To: Rulemaking on AP1000 Reactor Certification
DOCKET ID NRC-2010-0131

From: AP1000 Oversight Group

Re: CONTAINMENT FLAWS IN AP1000 DESIGN

Figure 1

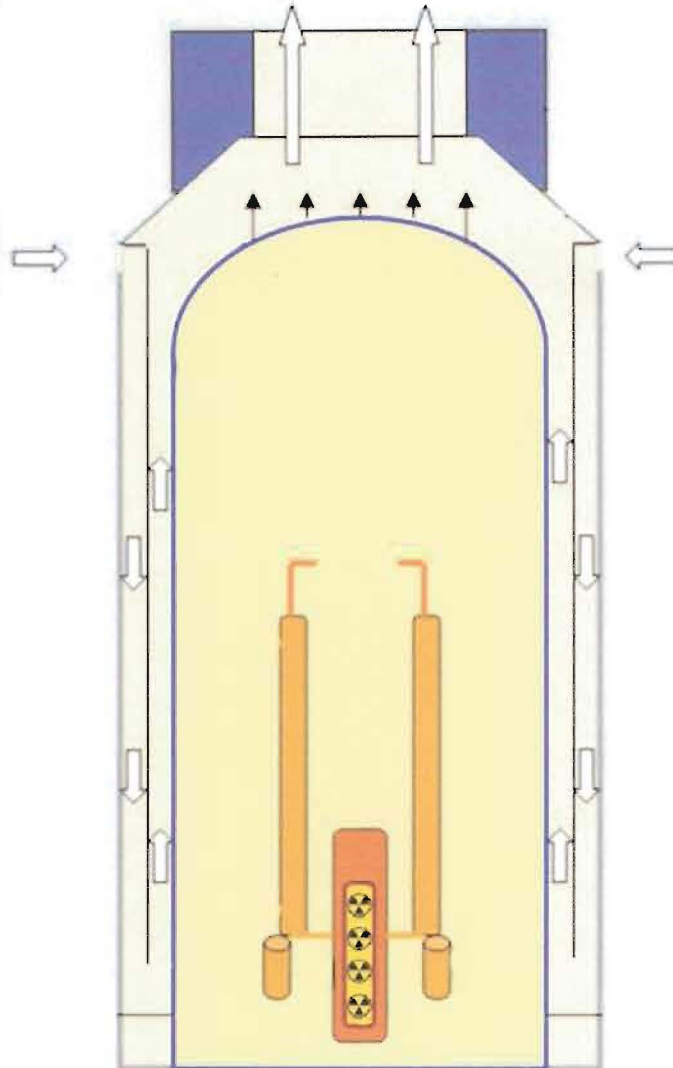
- Figure 1 – AP1000 in normal operation.
- Figure 2 – AP1000 design basis accident begins.
- Figure 3 – AP1000 containment hole opens as containment fills with radioactive gases.
- Figure 4 – AP1000 chimney effect draws radioactivity directly into the environment.
